**TOWN LAKE OF PARK
PLANNING & ZONING BOARD
STAFF REPORT**

**MEETING DATE: September 11, 2023
PZ-23-06**

APPLICATION: Empire Landscaping

**Re: Response to Engineering Comments: Empire Landscaping
Lake Park (MMA #23-015)**

SHEET
C1.1
OF 4

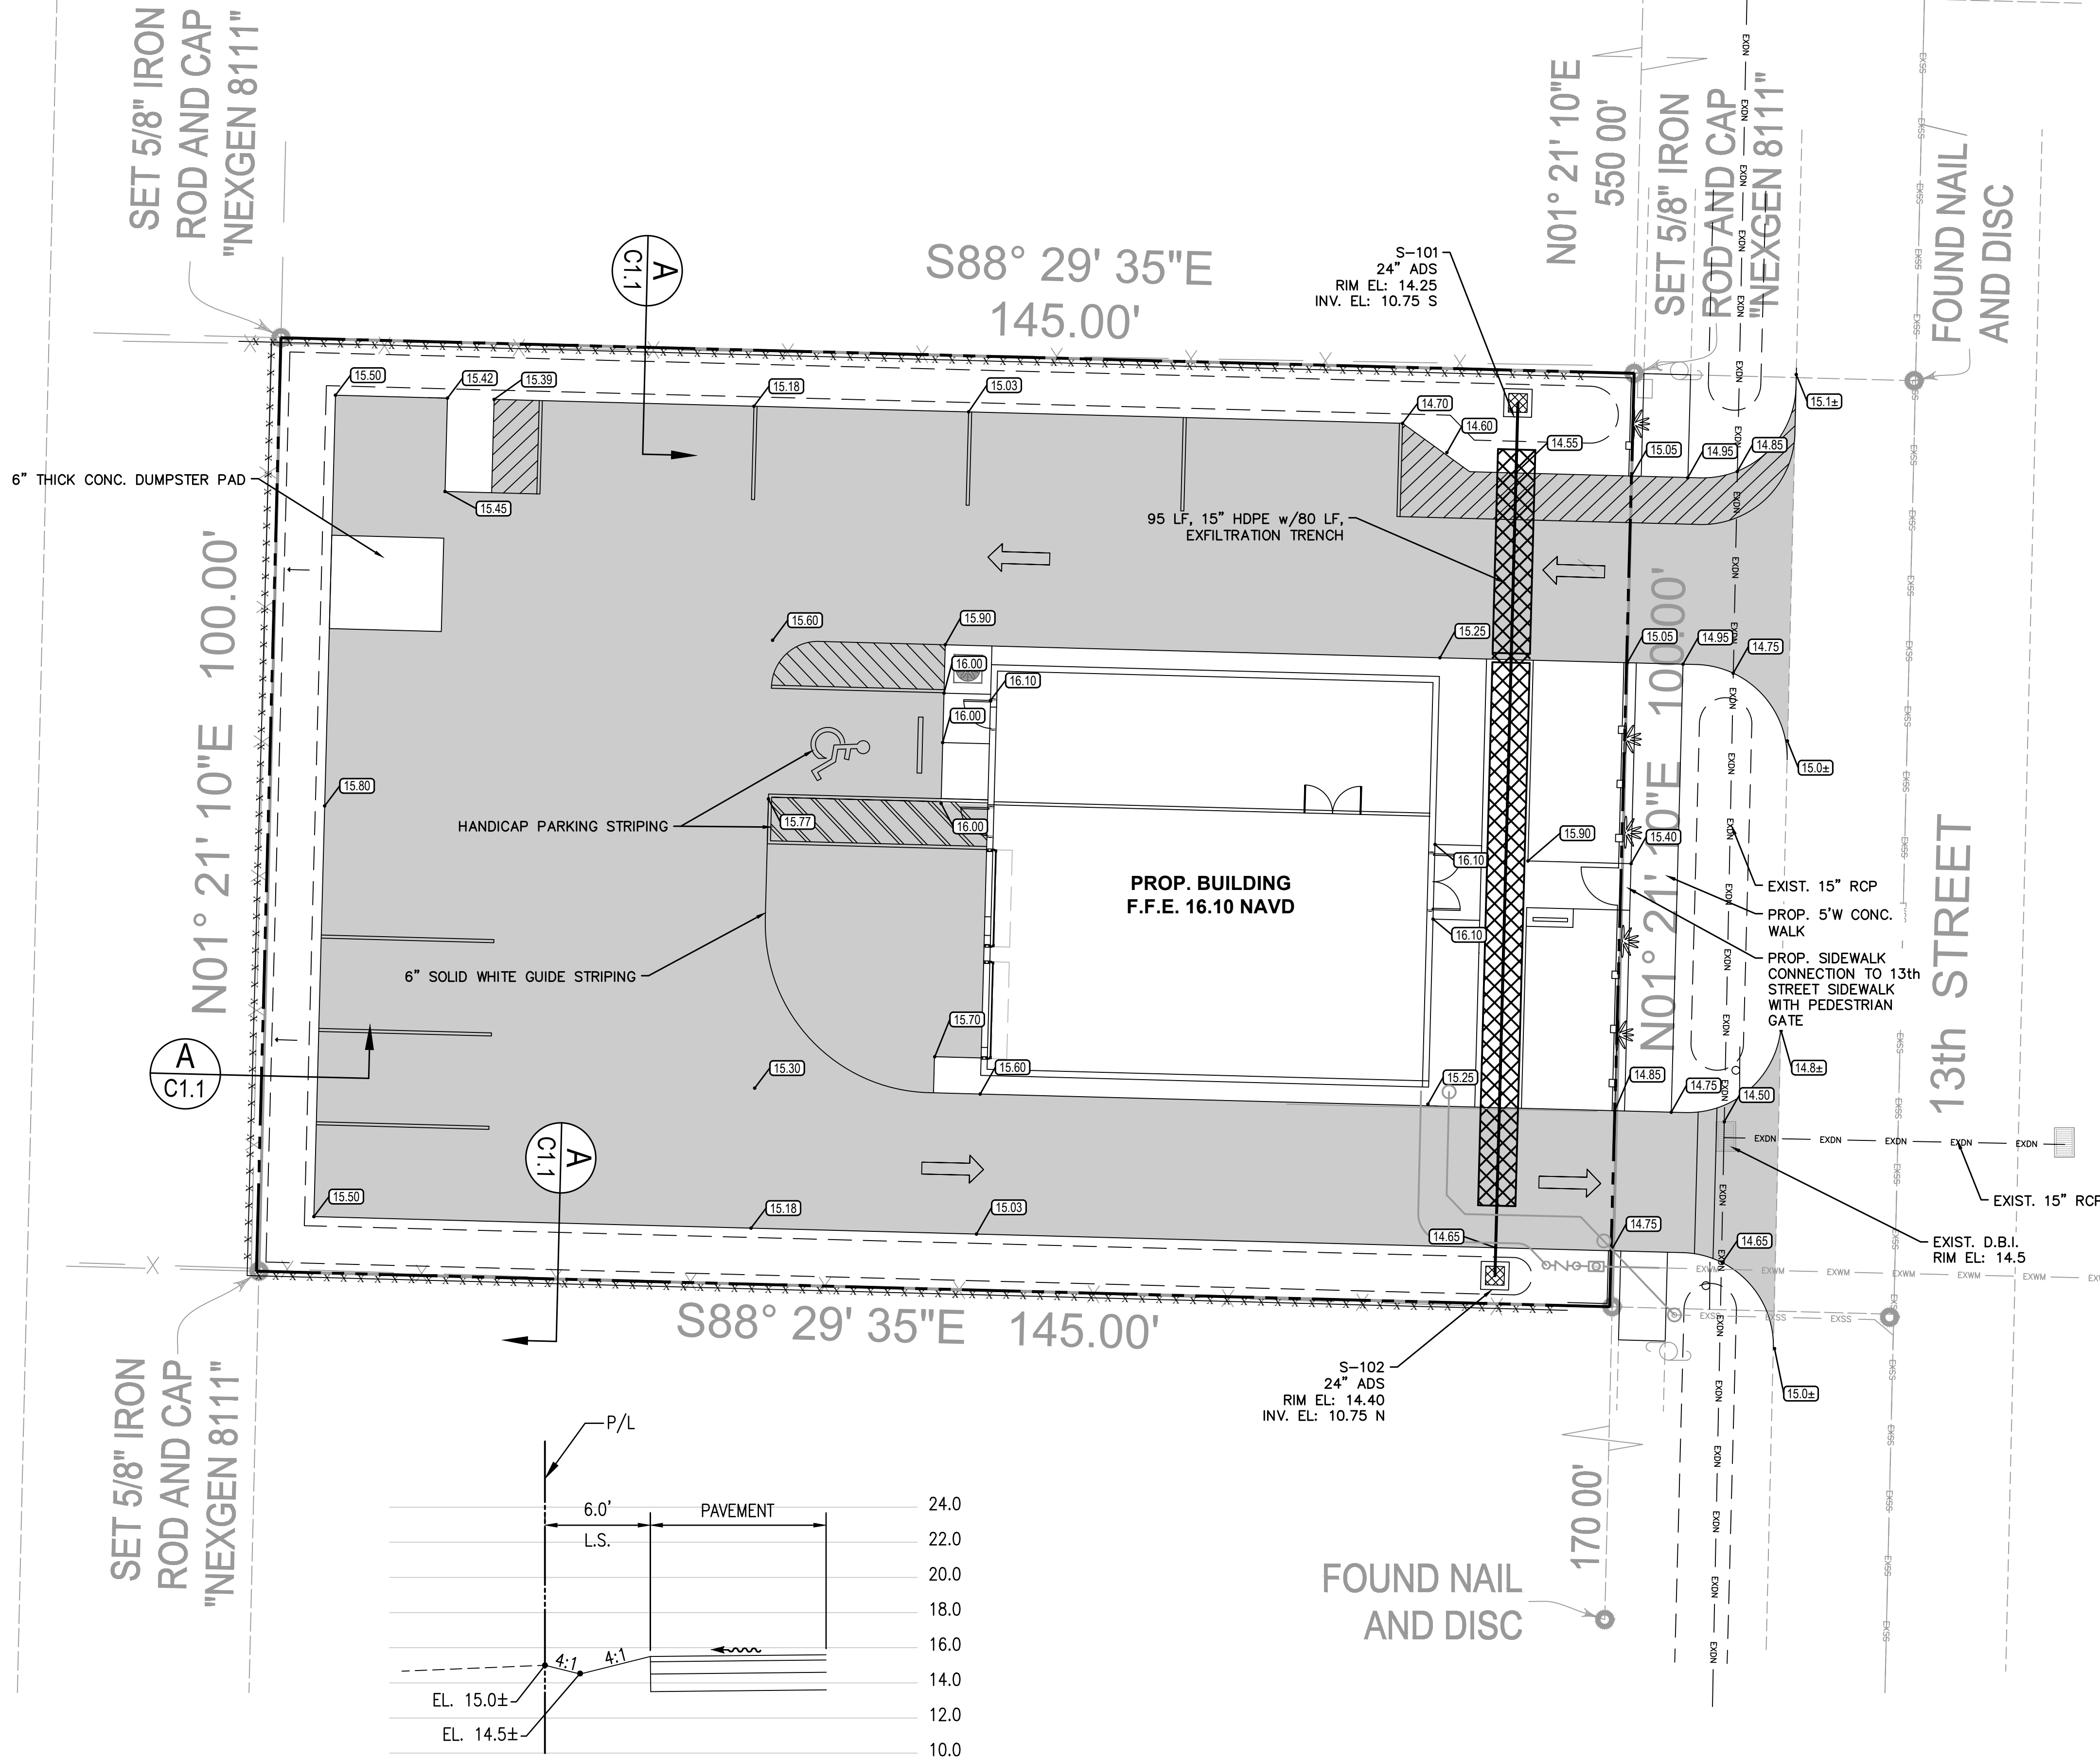
Comment: Civil plan shall include:

Comment: There might need to be some "island striping" or striping, just to guide vehicles on the correct path to execute the turns. An autoturn with the landscape trailer would be useful.

Response: Dumpster pad location called-out on sheet C1.1. Perimeter cross section for swale at property line added as Section A on sheet C1.1.

Response: Perimeter striping along the edge of the AutoTurn route has been added to assist truck with making the turns.
